**Noises from the Front Left or Right BOSE Mid-Range Speakers when Bass is Activated: Rework Speaker (SY 224/24)**

Model Line: **Taycan (Y1A / Y1B / Y1C)**

Model Year: **2025**

*Screws for loudspeaker in front door trim panel*

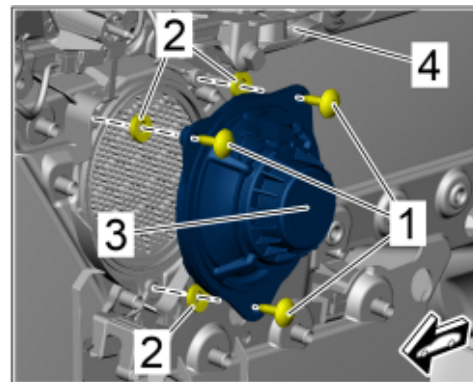
- 4 Remove screws securing speaker ⇒ *Screws for loudspeaker in front door trim panel -1-* and remove speaker ⇒ *Screws for loudspeaker in front door trim panel -2-* from door trim panel ⇒ *Screws for loudspeaker in front door trim panel -3-*.

*Position of washers*

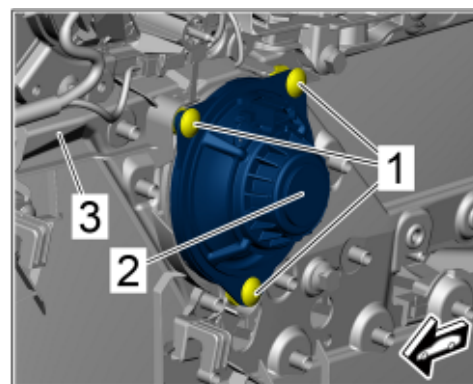
- 5 Using the screws securing speaker  $\Rightarrow$  *Position of washers -1-, position the washers  $\Rightarrow$  Position of washers -2- between the speaker  $\Rightarrow$  Position of washers -3- and door trim panel  $\Rightarrow$  Position of washers -4-.*
- 6 Carefully attach speaker  $\Rightarrow$  *Screws for loudspeaker in front door trim panel -2- to door trim panel  $\Rightarrow$  Screws for loudspeaker in front door trim panel -3- and screw-in and tighten screws securing speaker  $\Rightarrow$  Screws for loudspeaker in front door trim panel -1-.*

**Tightening torque 2,5 Nm**
